ADDENDUM NO. 3

July 19, 2023

RE: **GS# 211-071**
Hayden Hall Renovations
Perkinston Campus
Mississippi Gulf Coast Community College
Perkinston, Mississippi
A/E Project No. 22-050

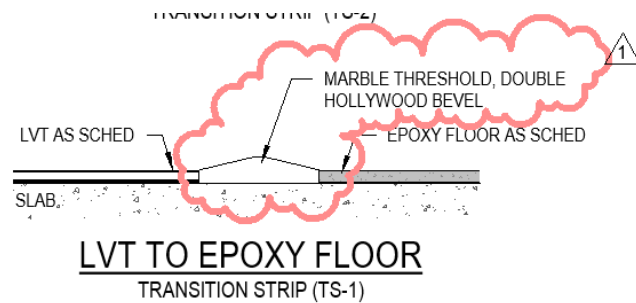
1. **Sheet D001 Demo Site Plan:** Delete sheet in its entirety and replace with the attached sheet “D001R1 Demo Site Plan”.
2. **Sheet D101 Overall Demo Plan – 2nd floor:** Delete sheet in its entirety and replace with the attached sheet “D101R1 Overall Demo Floor Plan – 2nd Floor”
3. **Sheet A001 - Site Plan:** Dtl 1 Site Plan, Replace partial portion of plan with below

1 OVERALL 2ND FLOOR DEMO
 3/32" = 1'-0"
 D101R1

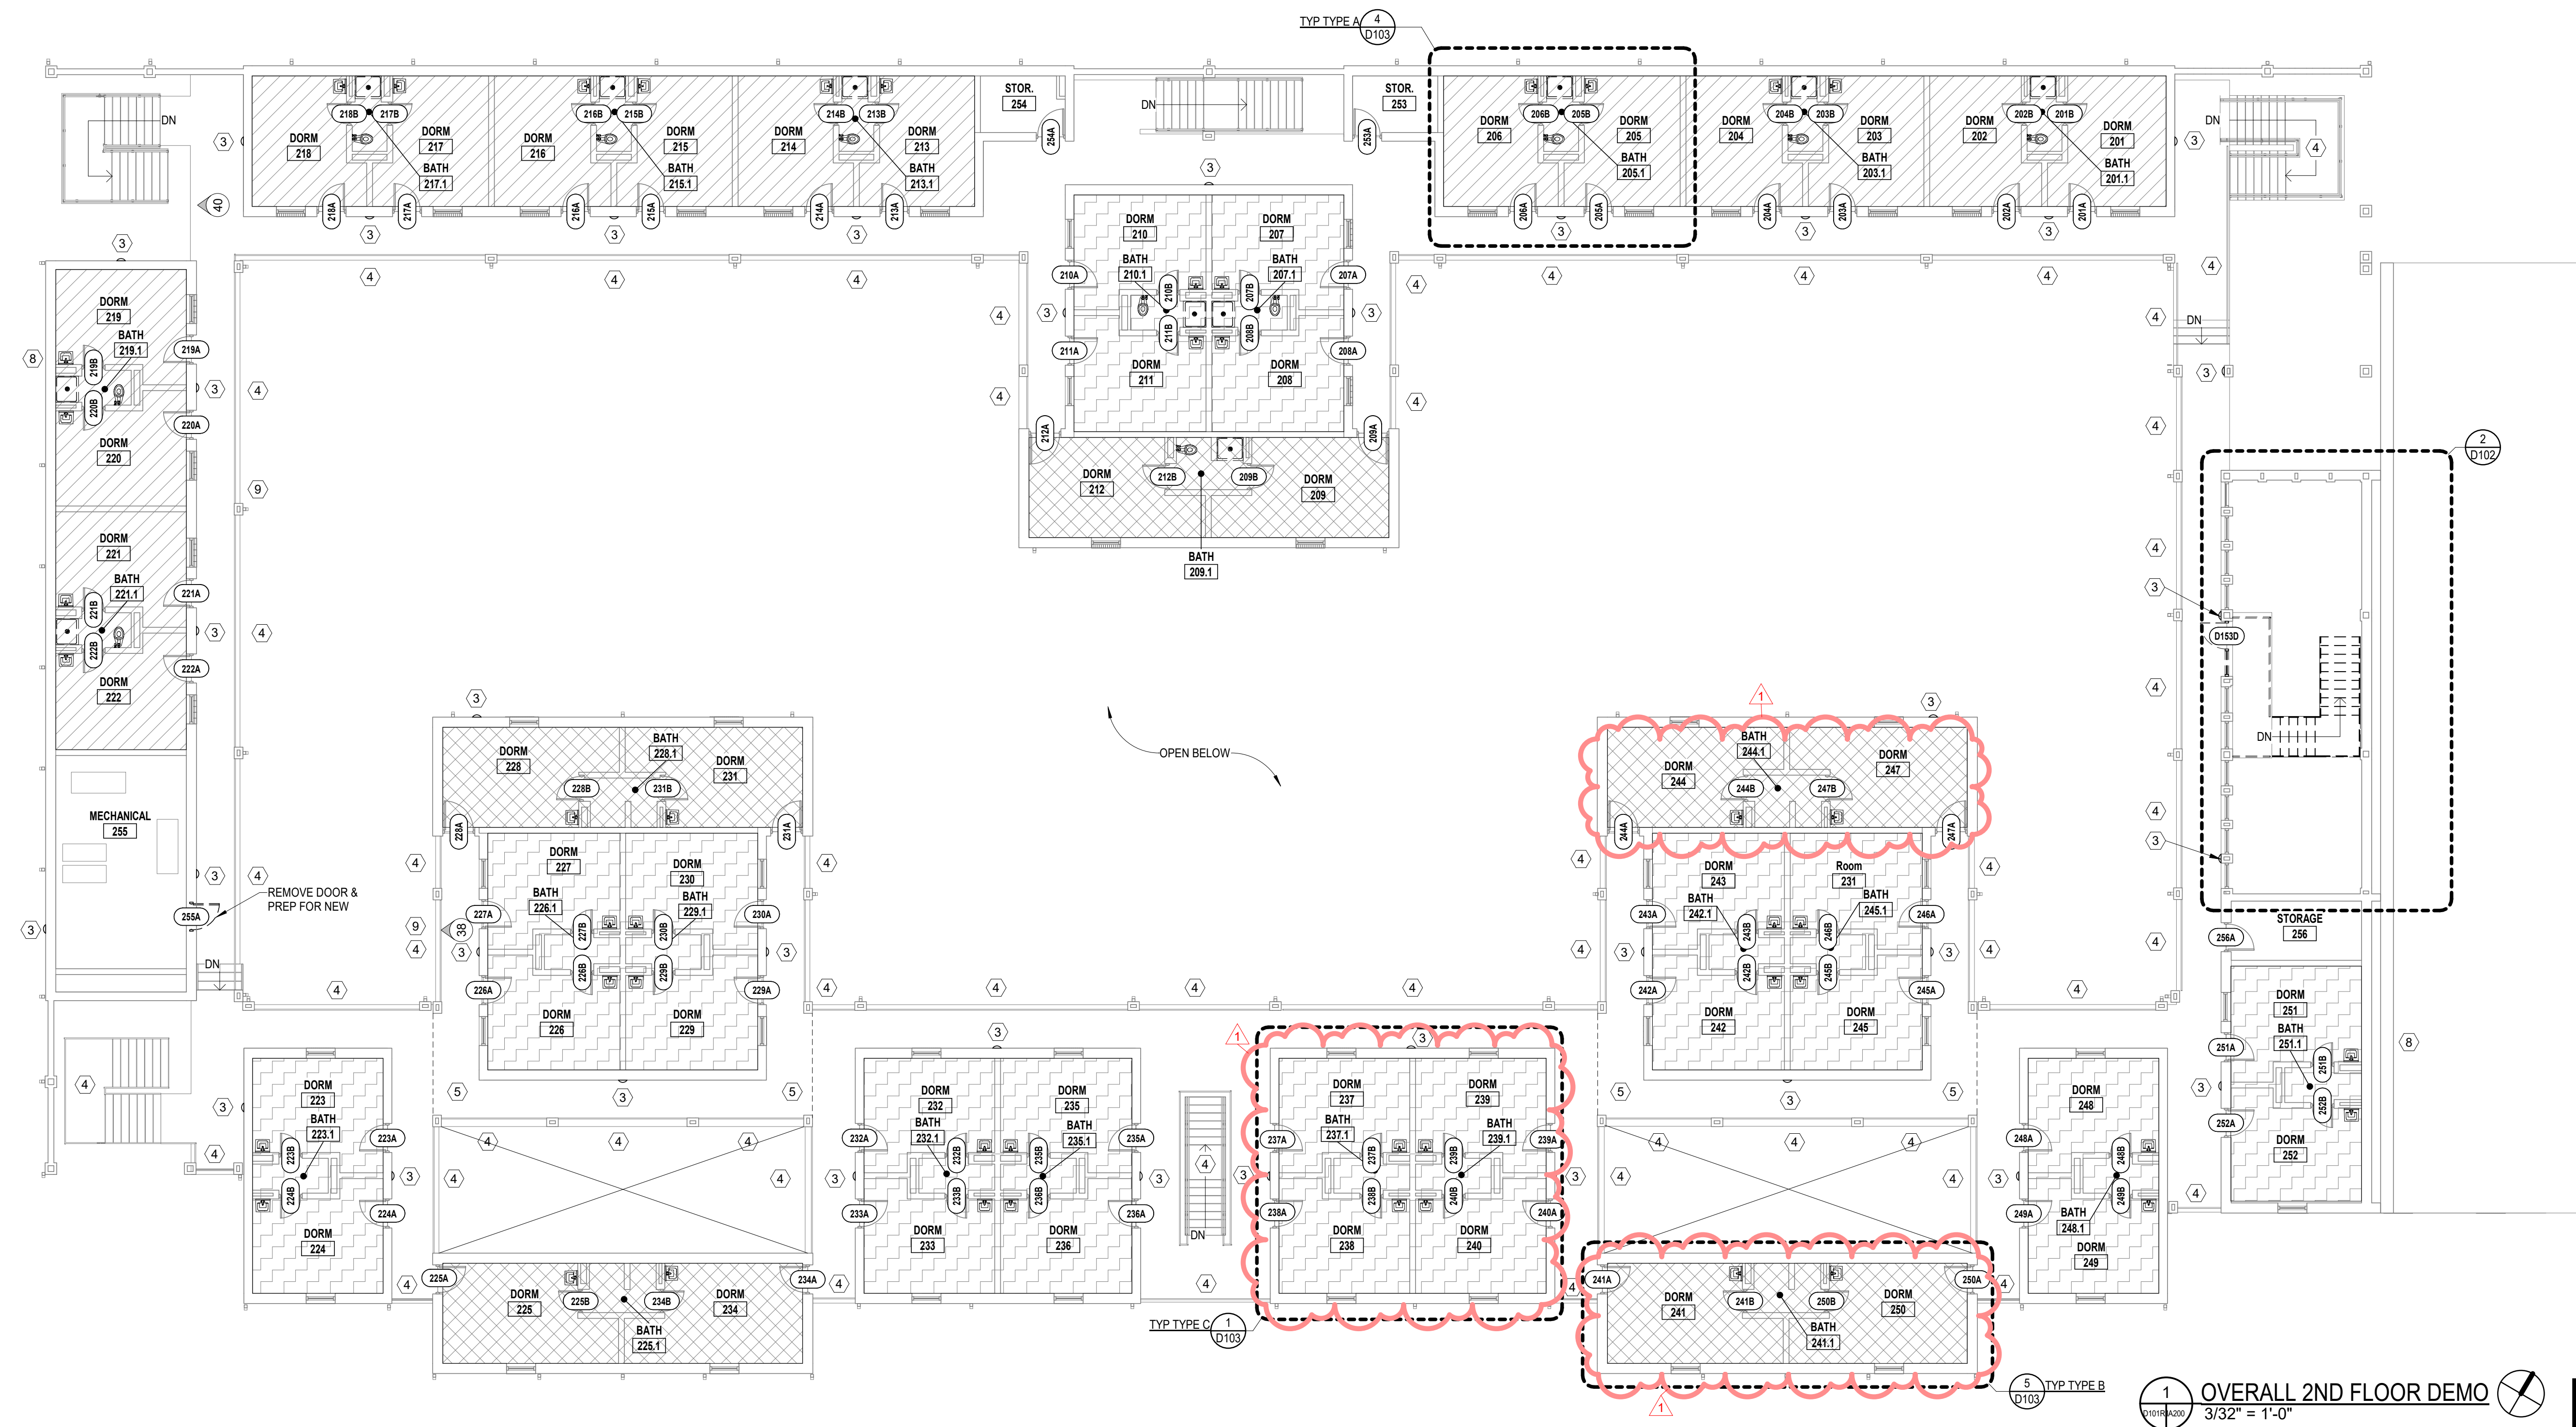
Q: Sheets D100 and D101 indicate the Dorm Types by hatching patterns and by enlarged plan callouts. See Floor Plan Legend for the hatching. I believe the hatching is correct on Sheet D100, but I believe it is incorrect on Sheet D101. The enlarged details are correct. For example, Dorm Type B is indicated by Enlarged Plan 5/D105. However, on Sheet D101, the hatching indicates it is Dorm Type C. The same occurs for Dorm Type D on Sheet D101. Architect may want to provide the correct quantities of each dorm type for clarification.

Q: Sheet D101 2nd Floor Demo. The dorms marked by Enlarged Plan callout 3/D103 (Dorm Type D) look like Dorm Type B layouts. Please clarify.

A: Hatching has been corrected on sheet D101 attached.

A: Dorm type B and D are similar, however, dorm type D is an ADA room while dorm type B is not ADA. There is no dorm type D on 2nd floor.

10 TYP DUMPSTER WALL SECTION
1" = 1'-0"
ALT#3

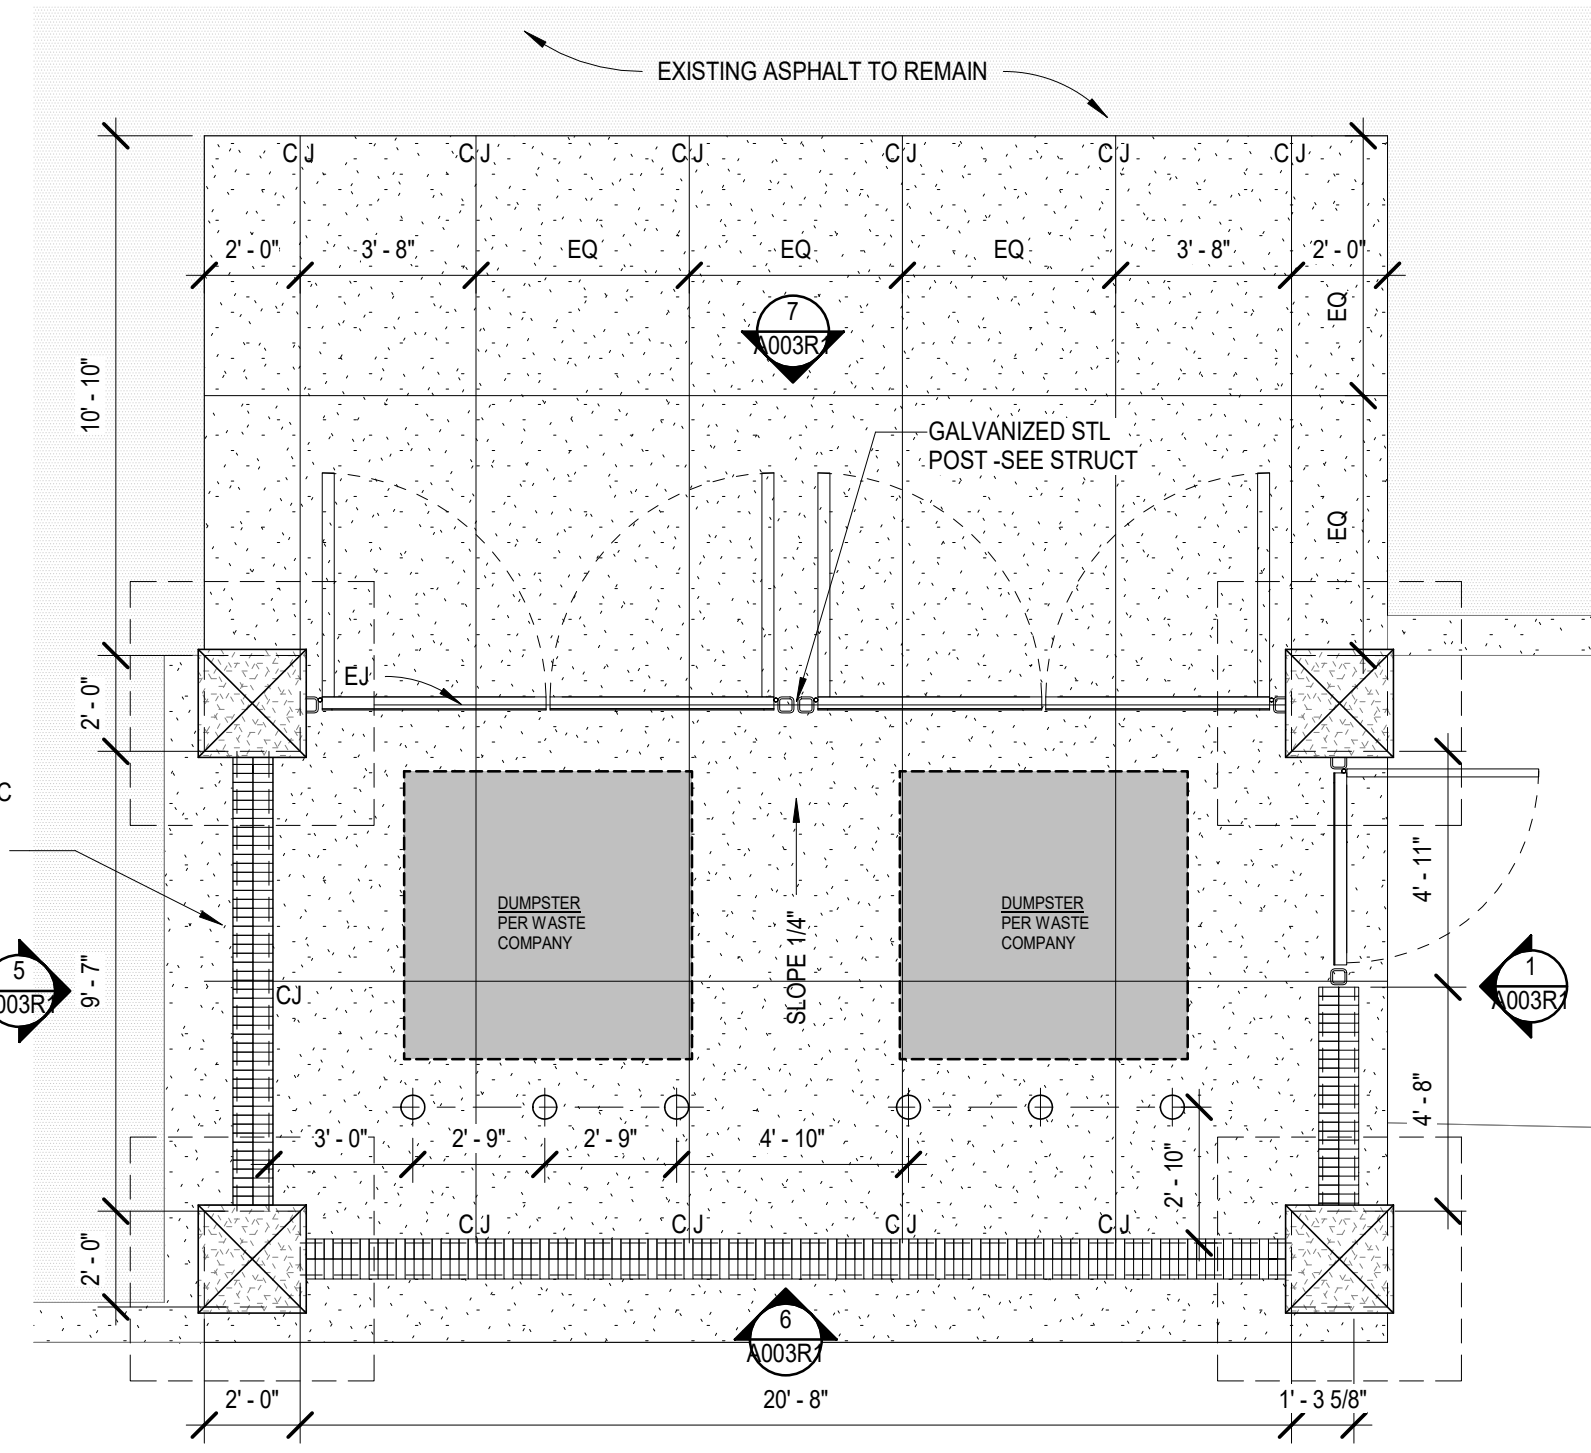
Q: What is the thickness of the new concrete dumpster pad? Will it require an aggregate sub-base? Please provide a detail.

A: See detail 10/A003 for thickness. 8" Concrete w/ #5 bars @ 12" O.C. EW, 4" Aggregate Base required.
